## ANN ARBOR HISTORIC DISTRICT COMMISSION

### Staff Report

**ADDRESS:** 200 East Washington Street, Application Number HDC14-060

**REPORT DATE:** May 8, 2014

<b>QUINN EVANS ARCHITECTS</b> 219 1/2 NORTH MAIN STREET ANN ARBOR MICHIGAN 48104 (734) 663-5888	<b>EAST WASHINGTON STOREFRONTS</b>  <h2 style="text-align: center;">Elevations</h2>	31401700
Scale: 1/8" = 1'-0"		04/17/14 Sketch Number: <h1 style="text-align: center;">A 201</h1>

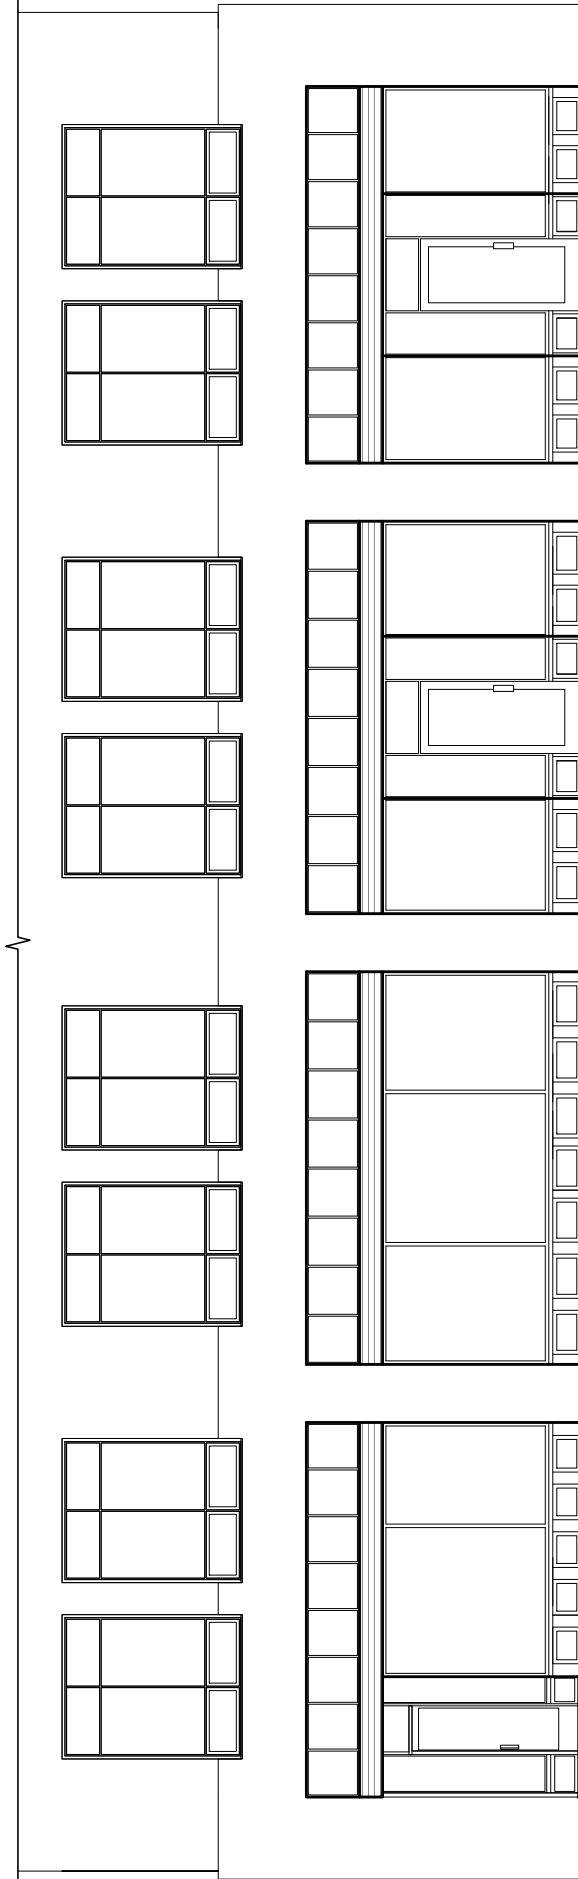
1. Based on the style and appearance of its components, the existing storefront is believed to be from the period of significance (pre-1943) for the Main Street Historic District. It features plate glass set in steel, with a metal trim piece surrounding the edges. Some of the windows are divided by 2" steel muntins, but others are a single pane. Below the glazing is a wood kickplate (or bulkhead) made up of decorative panels with windows into the basement. Some of the windows still exist and function as windows, some have been painted over, and some have been boarded up.

4. On East Washington, the east window has two large display panes, with six small windows in the kickplate. The west window is one large piece of glass with four windows in the kickplate. In the corner entry on either side is a single pane of glass plus one kickplate window. On South Fourth, the north window is one piece of glass with five windows in the kickplate, and the south window is four panes of glass with seven kickplate windows. All of the transoms contain two panes of equal size. All of the storefronts on the building are now part of the application. All of the windows have awning gutters (or hoods) that appear in the early photos and renderings of the building.

6. Staff believes that the evidence presented by the applicant and the letter from the structural engineer are adequate proof that the storefronts have serious structural deficiencies that must be addressed. Addressing these problems will require dismantling the storefronts that exist today. If the Commission agrees with staff on this, they must determine whether the use of the original materials, wood and steel, are technically or economically feasible, and if not, whether the proposed material change to aluminum is compatible. The sample aluminum section to be provided at the May 8 meeting will be invaluable to this determination.
